## ORIGINATION FORM

Proposed Revisions to a Standard Plans Index  
(Please provide all information — Incomplete forms will be returned)

Index Number: 102-602  
Sheet Number (s): 1 of 2  
Index Title: Two-Lane and Multilane, Work on Shoulder

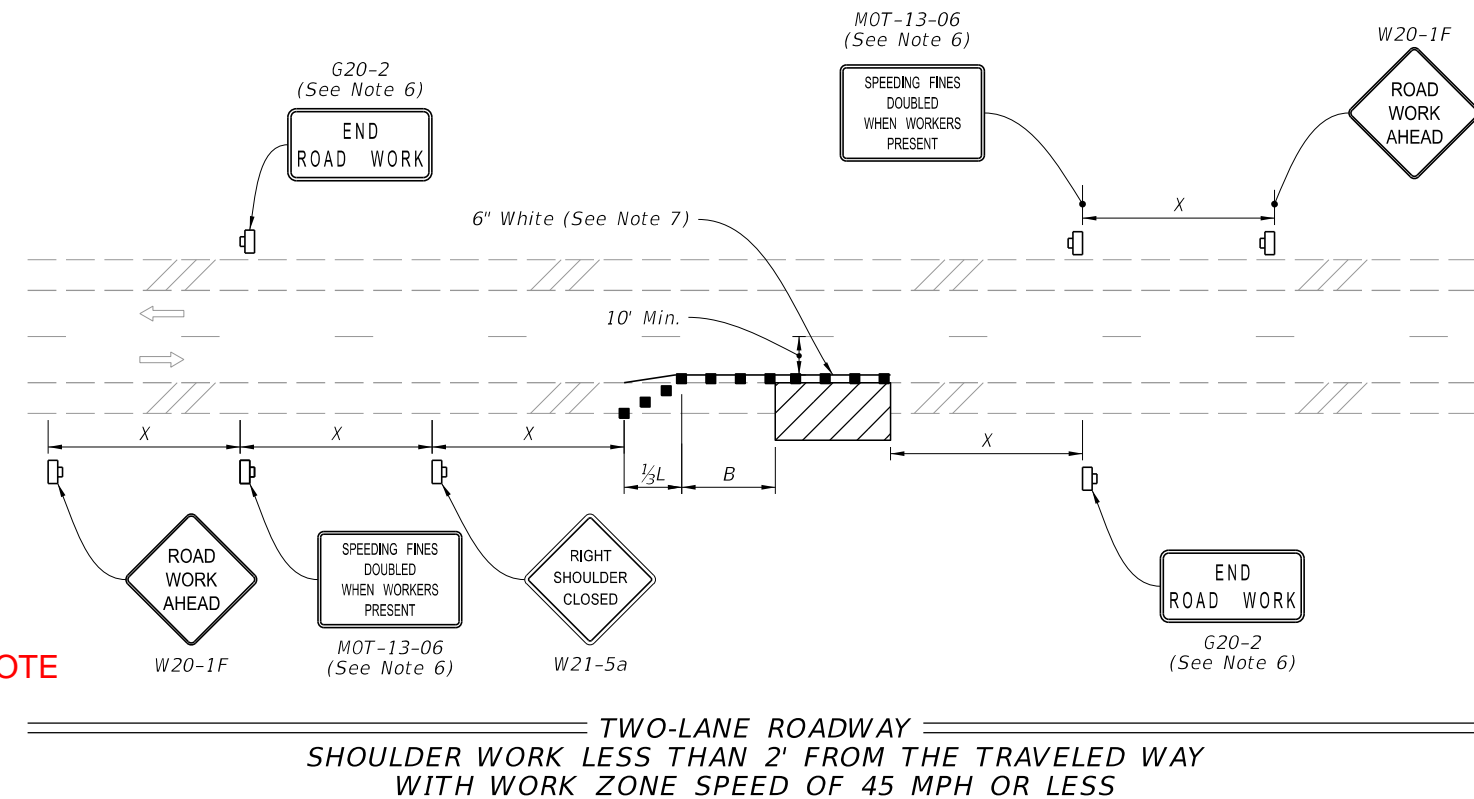
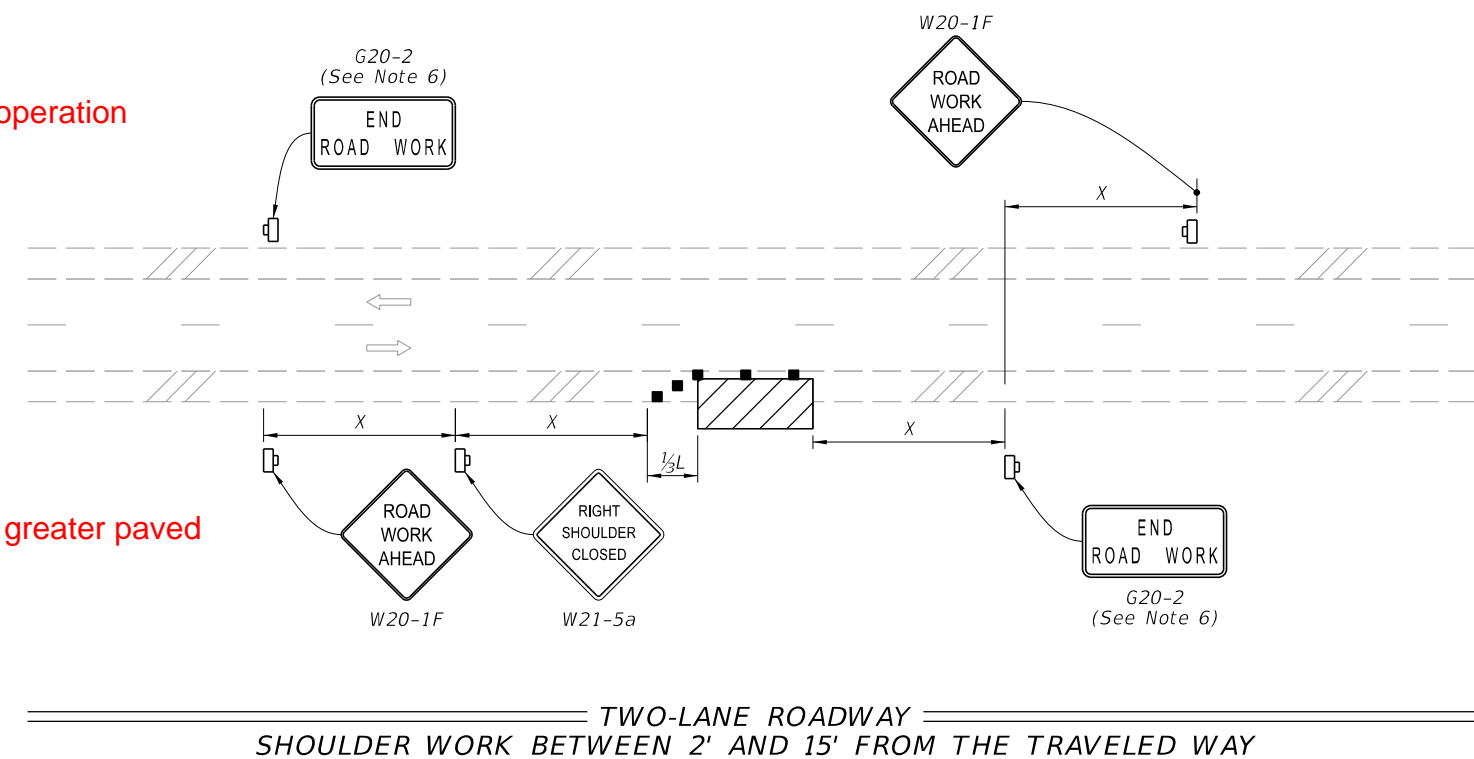
UPDATED NOTE

CHANGED TO: work operation

CHANGED TO: operation

CHANGED TO: 4' or greater paved

Sheet 1: Updated Note 3 to "Where work activities are between 2' and 15' from the edge of traveled way, the Engineer may omit signs and channelizing devices for work operations 60 minutes or less"; Changed Note 8 - "ridable shoulder" to "4' or greater paved Shoulder".

Wanted to make sure the area discussed was the specific work operation and not the limits of construction. Changed Note 3 to revert back to the previous duration that allowed engineers to omit signs and channelizing devices for work operations 60 minutes or less. changed "ridable shoulder" language to "4' or greater paved shoulder to be clear as to what we mean and not introduce a new term.

LAST REVISION 11/01/21	REVISION	DESCRIPTION:	 FY 2022-23 STANDARD PLANS	TWO-LANE AND MULTILANE, WORK ON SHOULDER	INDEX 102-602	SHEET 1 of 2
---------------------------	----------	--------------	--	--	------------------	-----------------

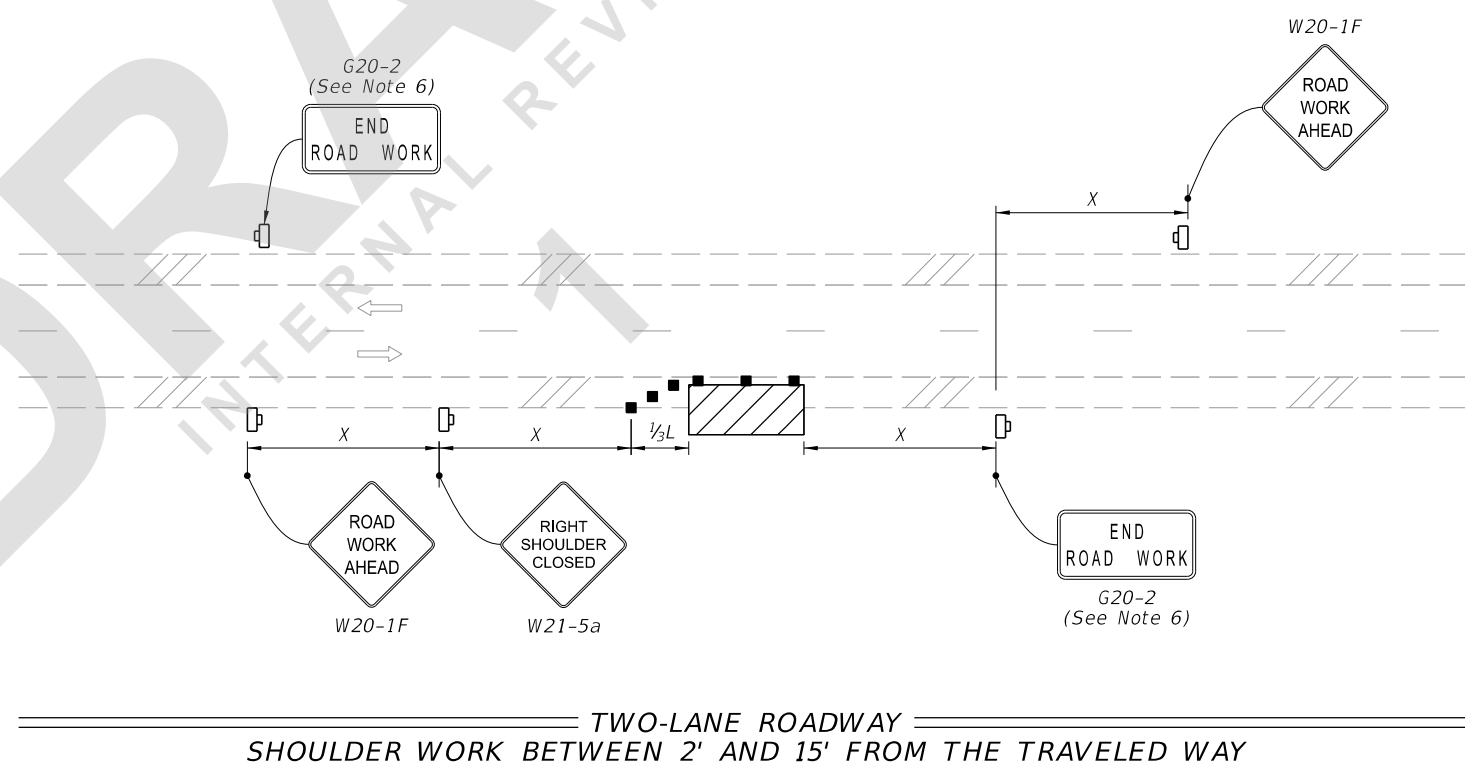
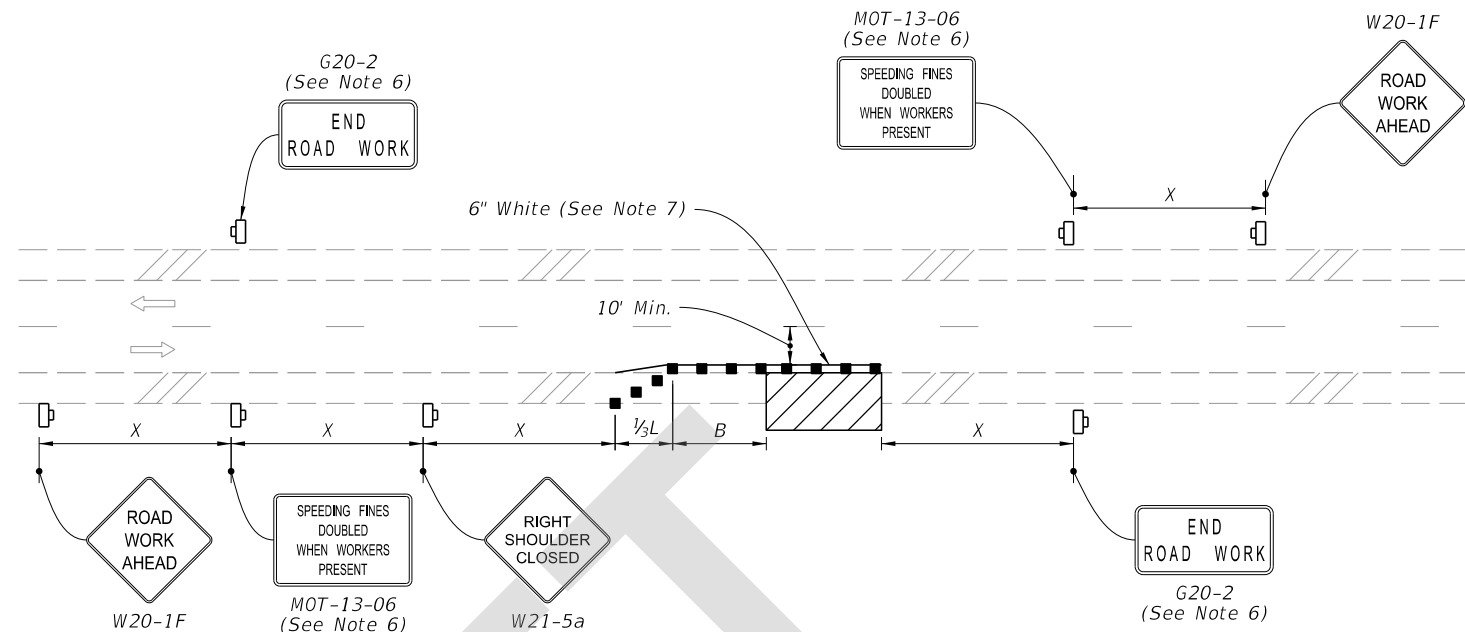
3. Where work activities are between 2' and 15' from the edge of traveled way, the Engineer may omit signs and channelizing devices for work operations 60 minutes or less.

7. Temporary pavement markings may be omitted when the work operation is in place for 3 days or less.
8. If the work encroaches on a marked bicycle lane or 4' or greater paved shoulder, close the lane or shoulder in accordance with the Plans.
